PL201600098  
PL2016-98

9101 CEDAR AVE.  
CONCEPTUAL SITE PLAN

PL201600098

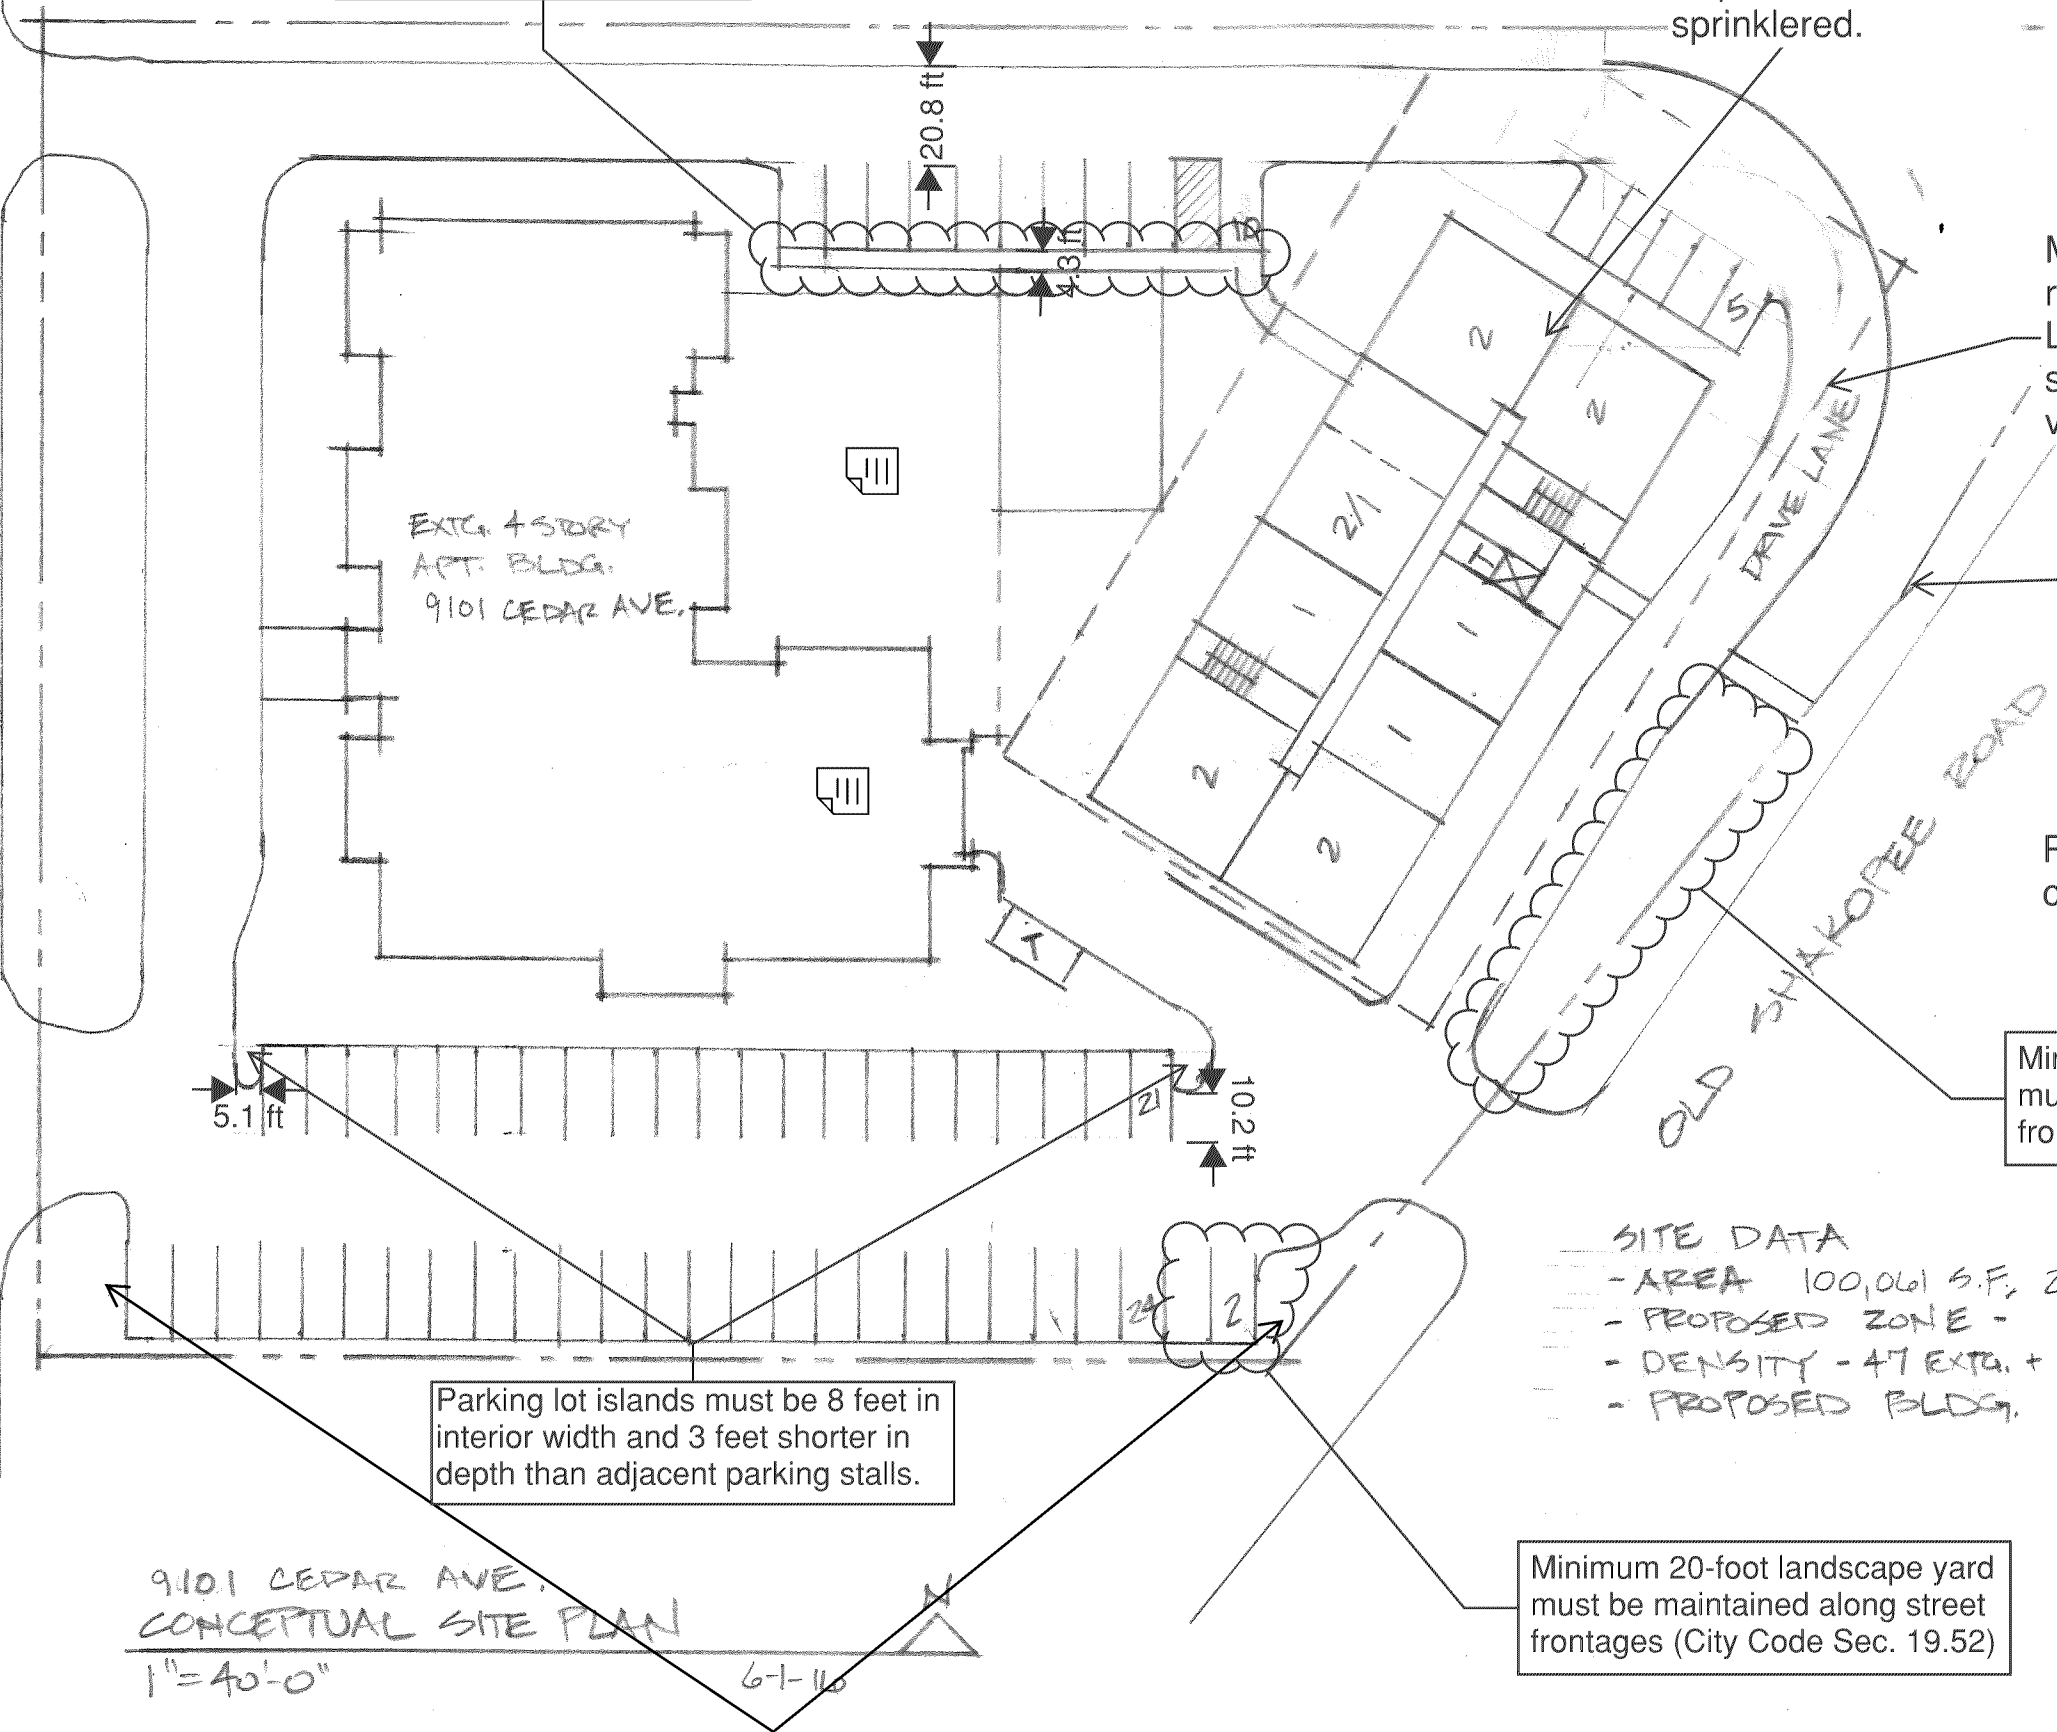
Sidewalk must be minimum 7 feet adjacent to parking and 5 feet otherwise.

Drive aisles adjacent to 90 degree parking must be a minimum of 24 feet in width.

New building required to be sprinklered.

Verify property line. City/County may need a small portion of ROW/Easement for a future project.

Minimum 20' wide with turning radius to accommodate BFD Ladder 3. Access road shall support the heaviest emergency vehicle - 40 tons.

Construct 8' sidewalk in new 12' sidewalk easement.

Provide additional hydrant coverage.

Minimum 20-foot landscape yard must be maintained along street frontages (City Code Sec. 19.52)

Minimum 20-foot landscape yard must be maintained along street frontages (City Code Sec. 19.52)

Parking lot islands must be 8 feet in interior width and 3 feet shorter in depth than adjacent parking stalls.

Must provide a solid three foot screen along any parking adjacent to the street.
